Re: Farm Road Homes 40B – Compendium of BoH Determinations, Comments, and  
Recommendations Regarding Public Health Requirements

Creative Land & Water Engineering, LLC (CLawe) has received and reviewed the comment from Sherborn BoH dated February 26, 2024. This letter provides our responses. To facilitate the review, we will quote the Reviewer's comments first in *italics* and follow-up with our response in **red**. This response is mainly to address the comments on septic system issues.

**Multi-Well PWS Layout**  
 (for purposes of concept illustration only)

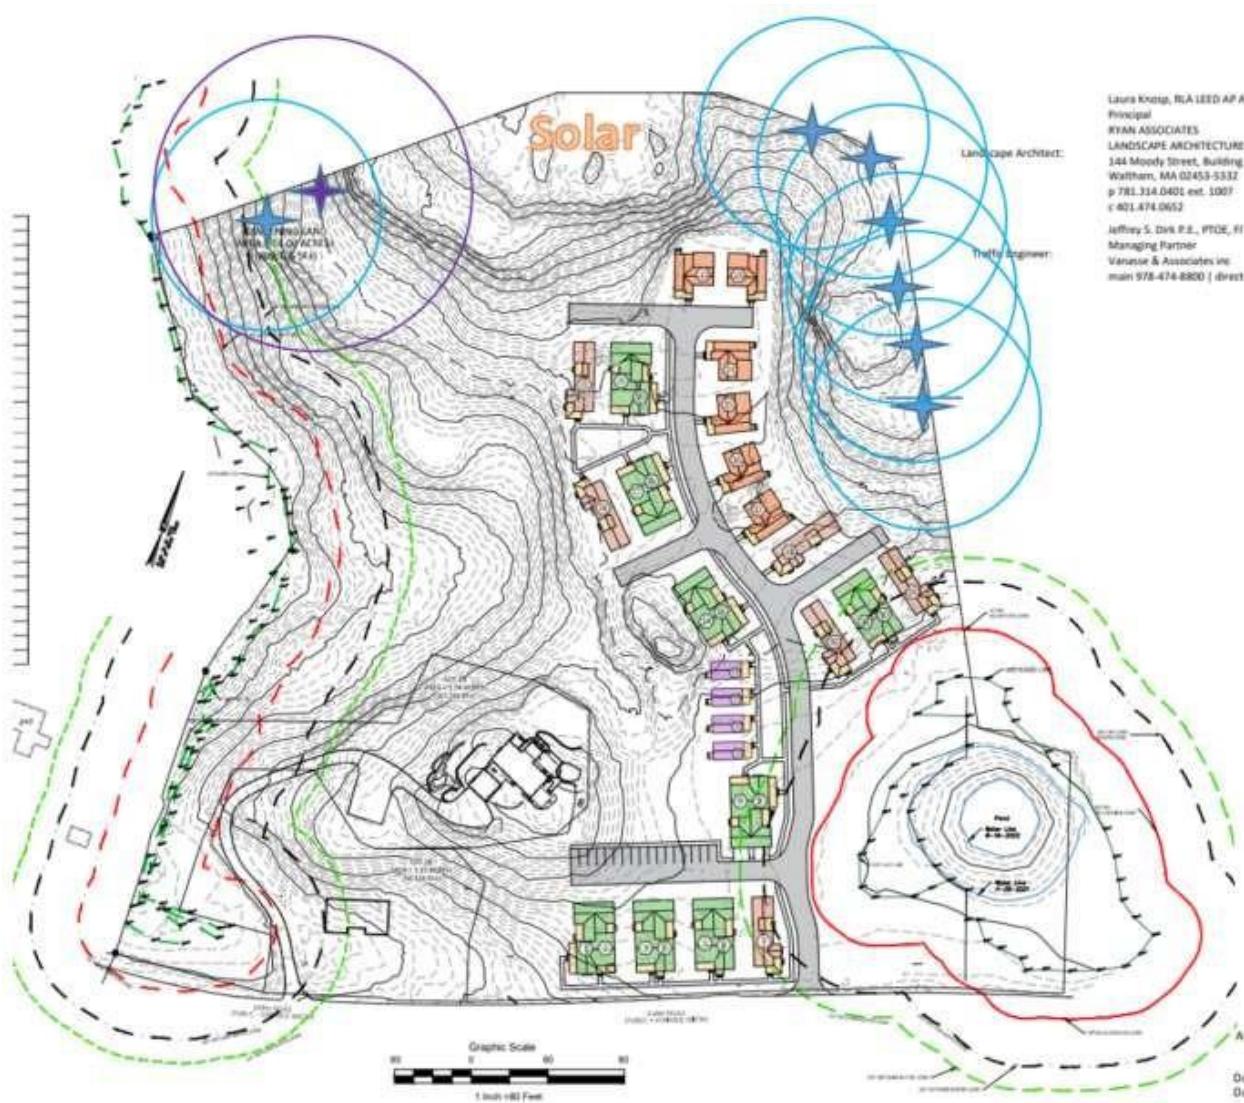
A rough illustration of a multiple-well PWS layout at the Farm Road site is presented below. It is not proposed as a required or even recommended layout. Instead, it merely demonstrates that alternative layouts may be possible.

Also note that having the Zone I's (the protective circles around each well) extend onto adjacent Town conservation land would require a formal agreement with the Town for compliance with MassDEP requirements for protection of PWS integrity.

**Response:** The Farm Road Homes has addressed the water supply issues in meetings and in writing:

1. The private water supply is chosen based on the overall land ownership and the best setting to avoid direct impact between water supply wells and the common septic system.
2. The applicant has obtained a DEP confirmation that the private water supply layout.
3. The water supply wells as in diversified location will have less impact for their relatively smaller drawdown zone.
4. The local aquifer showed consistent productivity based on the near wells at 49, 53, 55, which showed consistent 10 gpm yield.
5. The private water supply well can be monitored and tested in more flexible and effective ways through consistent approval condition and ownership oriented interest based approach.

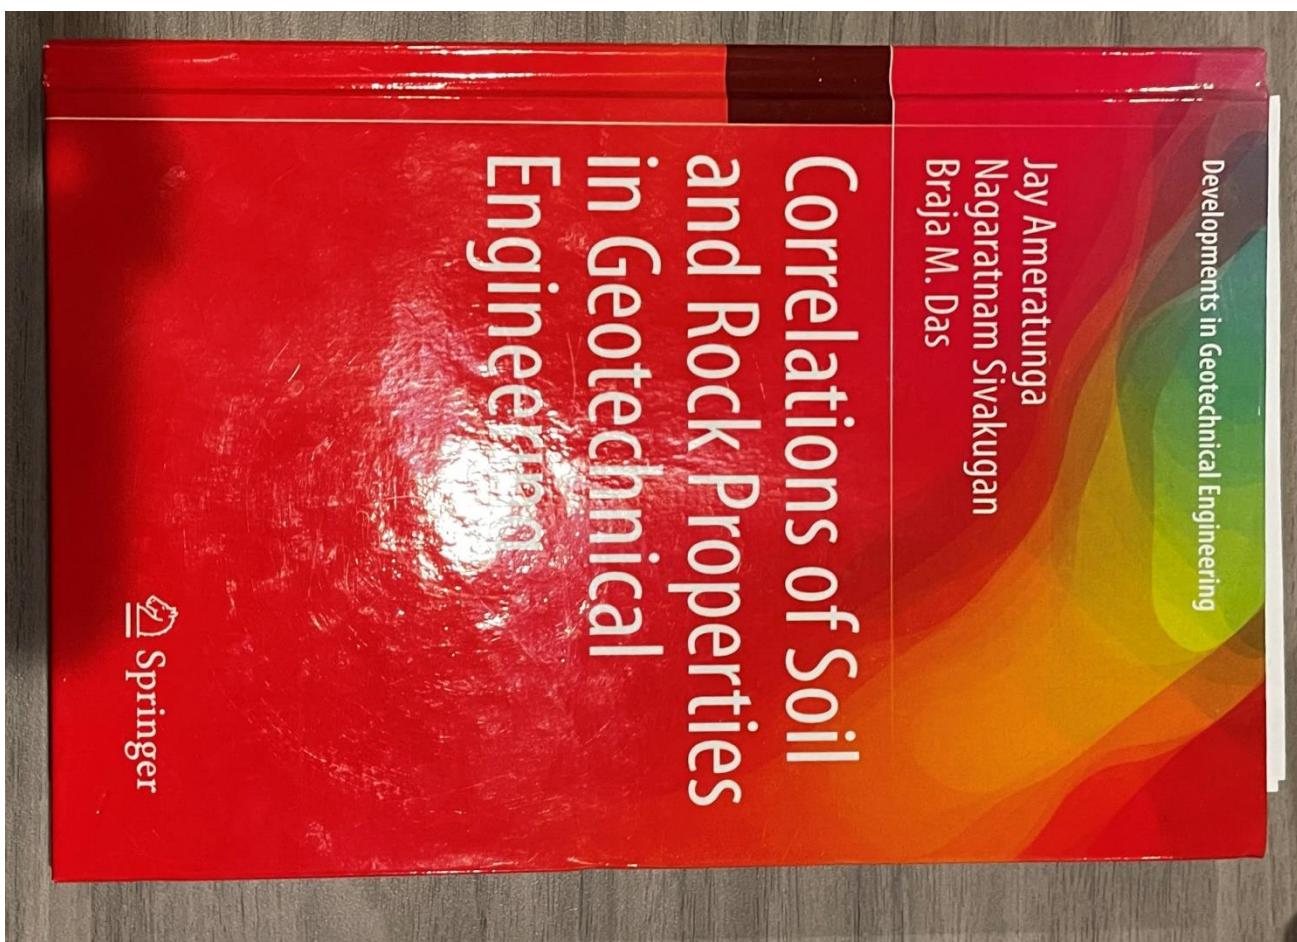
A key example of **data misapplication** involves percolation test and sieve analysis results being used in place of saturated hydraulic conductivity investigation. The purpose of percolation testing (or sieve analyses) is to determine whether septic effluent entering the soil absorption system will be able to infiltrate the soils immediately around and below that system readily, without causing back-up into the pipes, distribution chambers, beds, etc.

MassDEP's Stormwater Handbook notes that "***A Title 5 percolation test is not an acceptable test for saturated hydraulic conductivity. Title 5 percolation tests overestimate the saturated.***

Response: 1. We had a meeting with the peer reviewer and the BOH agent regarding how to approach the groundwater mounding analysis, specifically, discussion on mounding computer model, how to determine the aquifer depth and hydraulic conductivity as we discussed in our response to BOH agent 2/2/2024 letter in the supplementary part. The BOH "possible misapplication of data" was a total misunderstanding of our study for the following reasons:

- 4) Soil has different vertical and horizontal hydraulic conductivities in most non-homogeneous or heterogeneous soil. horizontal permeability (Kh) normally is significantly (10 times) higher than the vertical permeability (Kv). The percolation tested rate may count for 1/3 of vertical and 2/3 of horizontal value due to its test setting. If assume Kh = 5Kv, the percolation test result may be only 70% of the horizontal Kh. So it is conservatively used to estimate hydraulic conductivity.

Updated total water shed map to show groundwater recharge area to the reception boundary of the project site

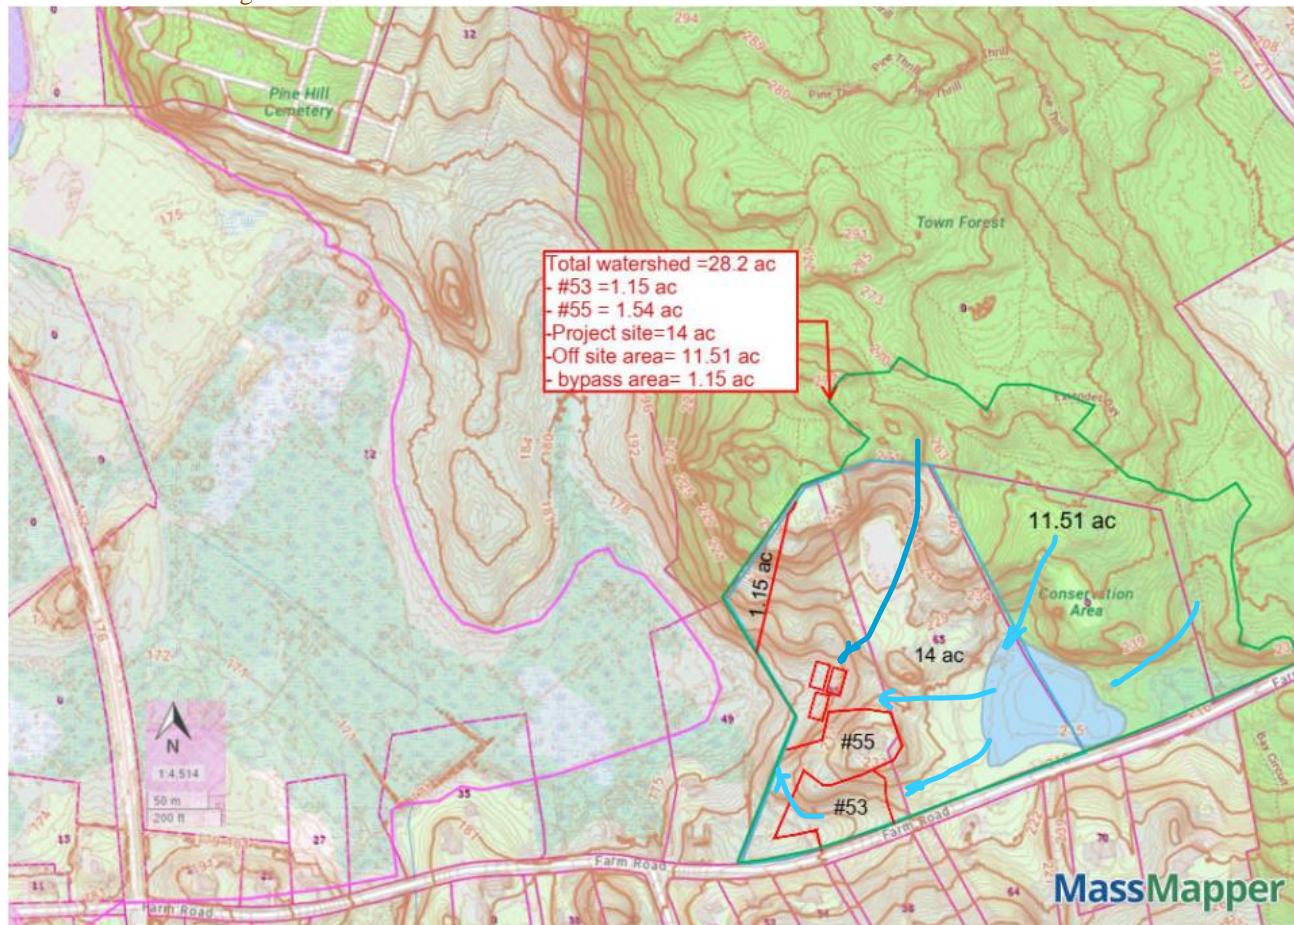
- Has overburden groundwater flow direction been determined by appropriate and sufficient monitoring well readings? A minimum of 3 triangulated points are needed to establish water table slope. Wet and dry season slopes may vary, as found by CLAWE during its testing at The Fields of Sherborn.

Response: As a common phenomenon, groundwater flow is mostly in line with surface water flow, especially in an open valley topography condition as we have in the project site SAS area. See the following drainage map showing a total drainage area with overall flow direction from north and northeast to southwest. The SAS is located in a broad valley with a sandy ground moraine in the middle which hosts 53 and 55 Farm Road. We also have done 39 soil test pits throughout the site. See Comprehensive Permit Plan sheets 15 and 16 in addition to the 8 soil testing in the SAA area. With 7 monitoring wells installed per BoH requirement. Using the soil test result and conservative assumption using top of ledge as the highwater if no water is encountered, we generated a high groundwater flow map and attached to this letter for reference. The groundwater flow direction as mapped is in agreement with the surface topography, which is found recharging groundwater towards west. The advantage of the project site is that there is additional 11.51 acres of off site conservation land upstream which provides additional recharge to dilute the nitrogen concentration with a total of 24.36 acres of watershed to the AOI area. This confirmed that the nitrogen analysis was conservative as it used only 22.88 acres for recharge area.
